Informal document **GRSG-116-25**
(116th GRSG, 1-5 April 2019
agenda item 2(a))

Specific Issues for M2-Buses of Class B with Transition from 05-series of UN Regulation No. 107 to 06-series of amendments

Requirements for Roof Hatches and Consequences

Cabin Size 1 (12-seater)

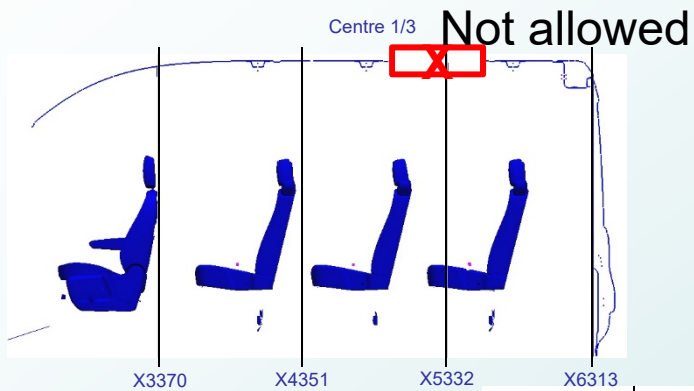
Roof Hatch Position Examples – Passenger Compartment = Front seat to rear door

“Same” positions,
but now allowed.
